# Work Order ID 75944

Item Name: Crosstube Turning Detail

<b>DART AEROSPACE LTD</b>	<b>Work Order:</b> 75944
<b>Description:</b> Crosstube Assembly (205/212 Low Aft)	<b>Part Number:</b> D212-664-247
<b>Inspection Dwg:</b> D212-664-247 Rev: B	<b>Page 1 of 1</b>

DRAWING NO. D212-664-247	TITLE CROSSTUBE ASS'Y (205 LOW AFT)	REV. B	<b>DART AEROSPACE LTD ENGINEERING ORDER</b>		D.E.O. NO. D212-664-247-B-1	SHEET NO. SHEET 1 OF 1	SCALE NTS
DRAWN <i>92</i>	CHECKED <i>ASS</i>	MFG. APPR. <i>AB</i>	APPROVED <i>WD</i>		DE APPR. <i>W</i>		
DATE 11.07.15	DATE 11.07.20	DATE 11.07.21	DATE 11/07/21		DATE 11.07.21

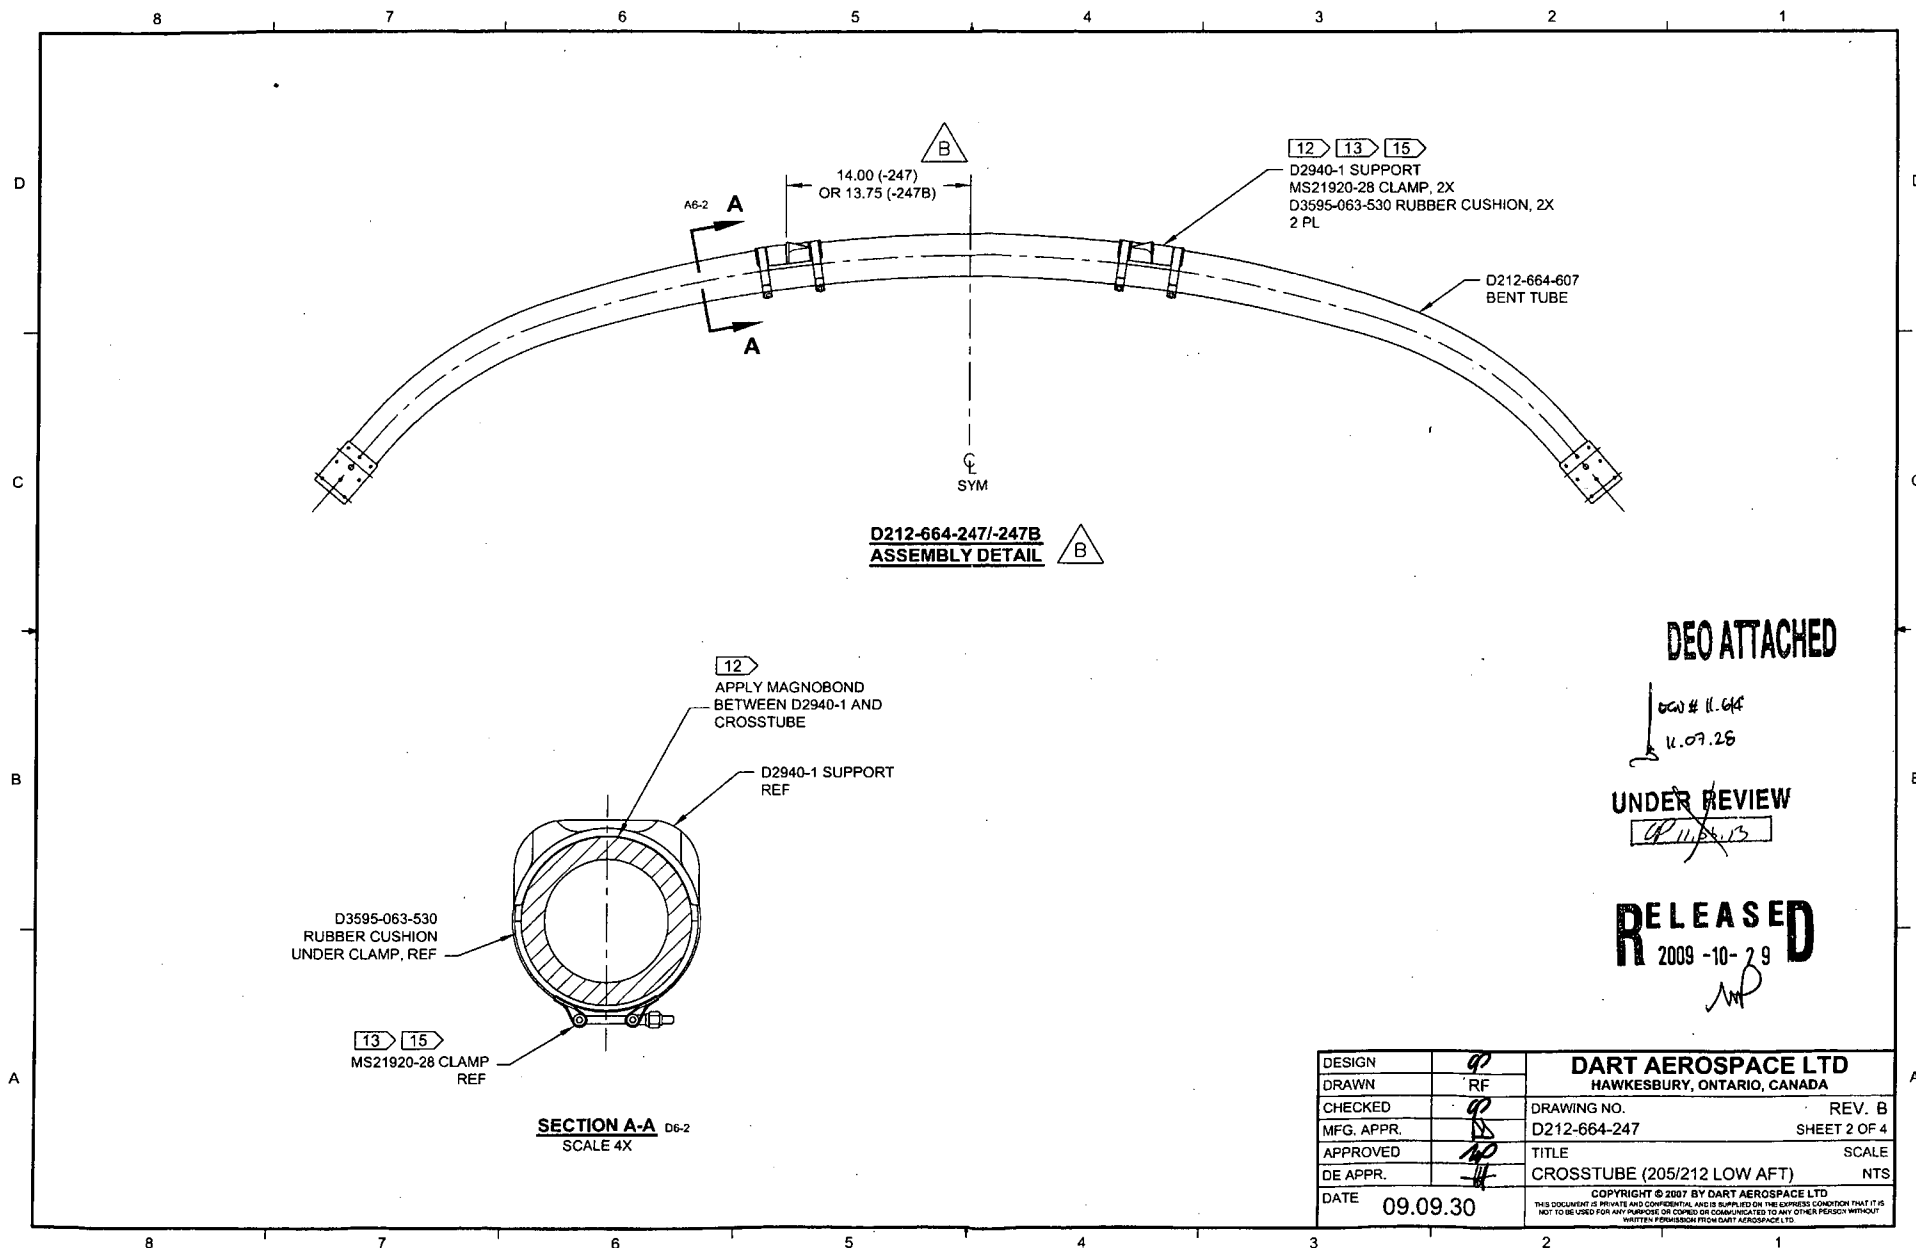
**PURPOSE:**  
REPLACE MAGNOBOND WITH PROSEAL.

NOTE 12 & 15, SHEET 1 IS AMENDED AS FOLLOWS:

- 12) TO INSTALL D2940-1 SUPPORT: ABRASE MATING SURFACE OF SUPPORT AND CROSSTUBE WITH 180-GRIT SANDPAPER AND REMOVE RESIDUE WITH MEK (OR EQUIVALENT). APPLY A 0.04" TO 0.07" THICK LAYER OF PROSEAL 890 CLASS B-2 (OR AMS-S-8802 CLASS B-2) SEALANT TO MATING SURFACE OF SUPPORT.
- 15) TORQUE CLAMPS 80 TO 100 IN-LB. ENSURE AT LEAST 1.5 THREADS SHOWING IN SAFETY AND THAT NUT HAS NOT BOTTOMED-OUT AFTER TORQUING. **PRIOR TO PACKAGING, RE-CHECK TORQUE ON CLAMPS AFTER PROSEAL 890 SEALANT HAS CURED FOR 72 HOURS.**
